SUBJECT: Forwards addl info requested by NRC 800328 ltr re environ  
 qualification of electrical equipment. Info provided  
 virtually identical to utl 790810 ltr. Requests that  
 analysis make use of previously supplied info.

Subject: Environmental Qualification of Electrical Equipment  
R. E. Ginna Nuclear Power Plant  
Docket No. 50-244

RESPONSES TO TELECOPY FROM R. SNAIDER TO RG&E  
5/1/79 - SEP TOPICS VI-2.D and VI-3,  
"MASS AND ENERGY RELEASE INSIDE CONTAINMENT"

EQUIPMENT RESIDUAL HEAT EXCHANGERSYSTEM AUXILIARY COOLANTPROJECT GINNA

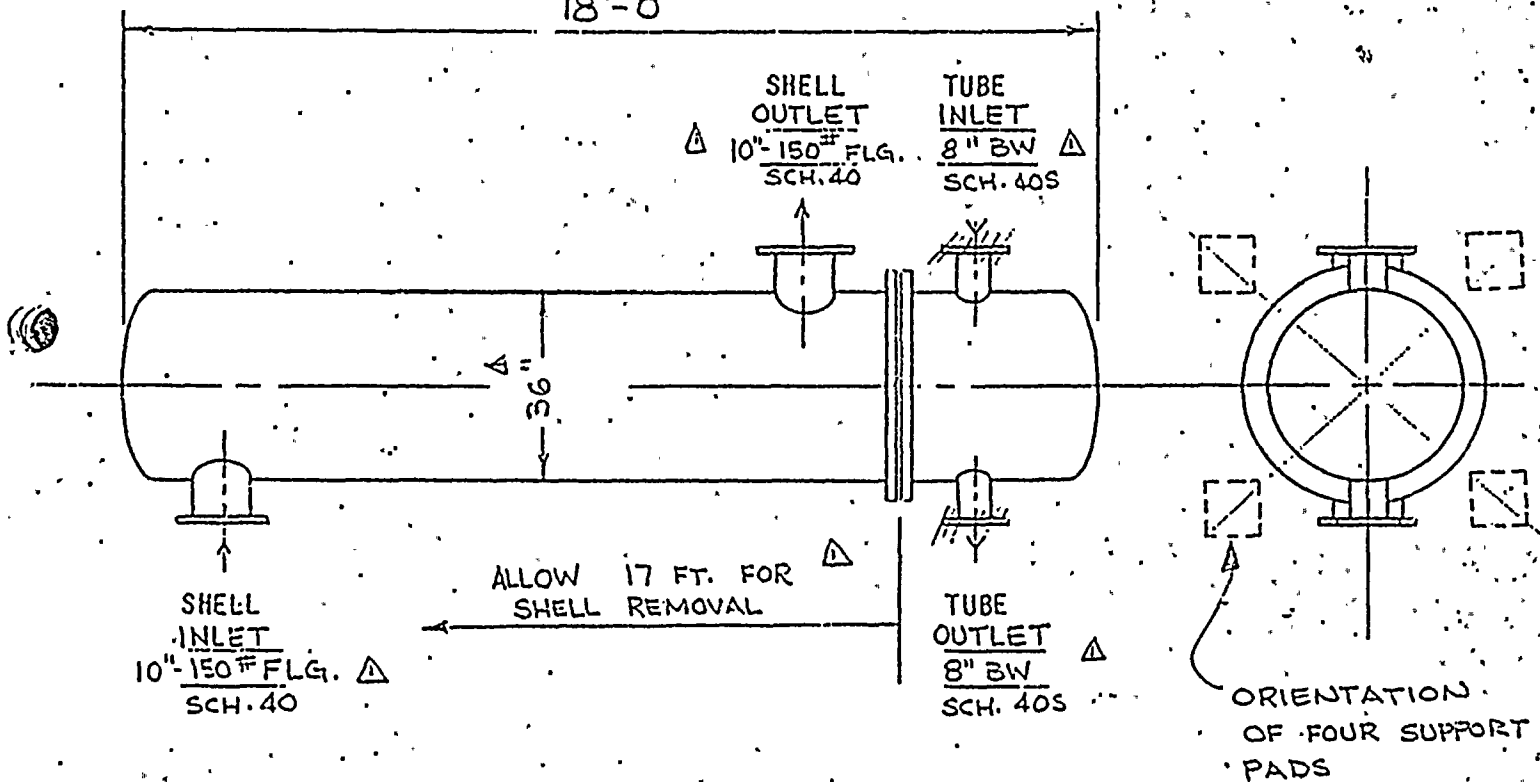
There are no spray heat exchangers; however, the Residual Heat Removal (RHR) heat exchanger provides for long-term cooling of water being recirculated from the containment sump. Attachment 1 provides information on the RHR heat exchanger.

$$UA = 7.48 \times 10^5 \text{ BTU/HR. } ^\circ\text{F}$$

~~MAY BE~~ INSTALLED VERTICALLY ~~OR HORIZONTALLY~~  
ON FOUR FEET

APPROX. DRY WT. 9000 LBS. (FLOODED: 13800 LBS)
